## **11<sup>th</sup> January 2024 Planning Committee Addendum**

### **Item 6.1 21/02431/FUL – Development Site Former Site Of 17 - 21 Dingwall Road, Croydon, CR0 2NA**

### **Item 6.2 23/02918/FUL - 29-31 Hollymeoak Road CR5 3QA**

PROPOSED SECTION C - C

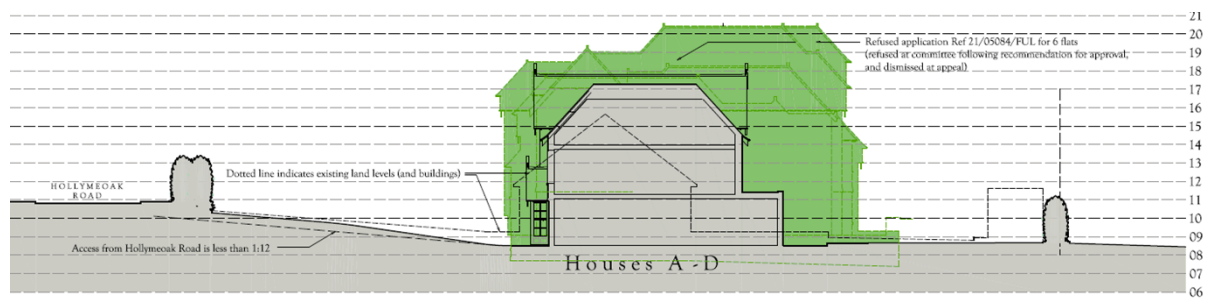
In para 7.11, the section drawing shown within the agenda report actually compares a previously refused flatted scheme (22/01498/FUL) rather than the dismissed appeal development (21/05084/FUL). The section and comparison for the current and dismissed scheme is shown below – proposed section C-C:

PROPOSED SECTION B - B

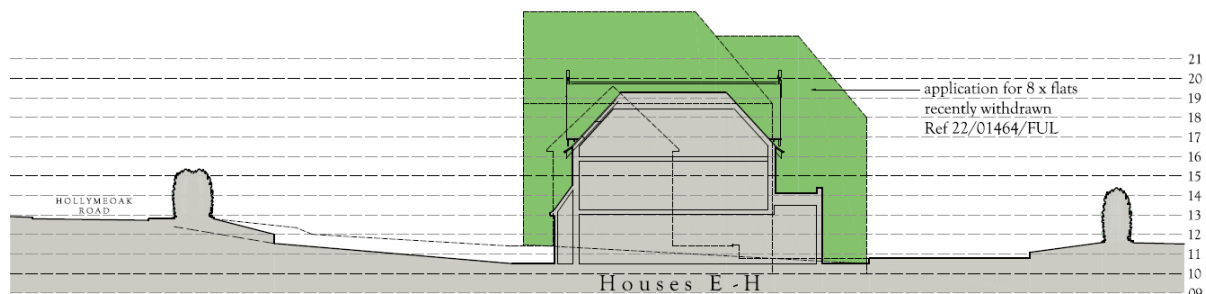
Section B-B below shows the proposed development on the plot of no.31 Hollymeaok Road and compares it with an application for 8 flats on the site (22/01464/FUL) which was ‘finally disposed of’ by the Local Planning Authority.
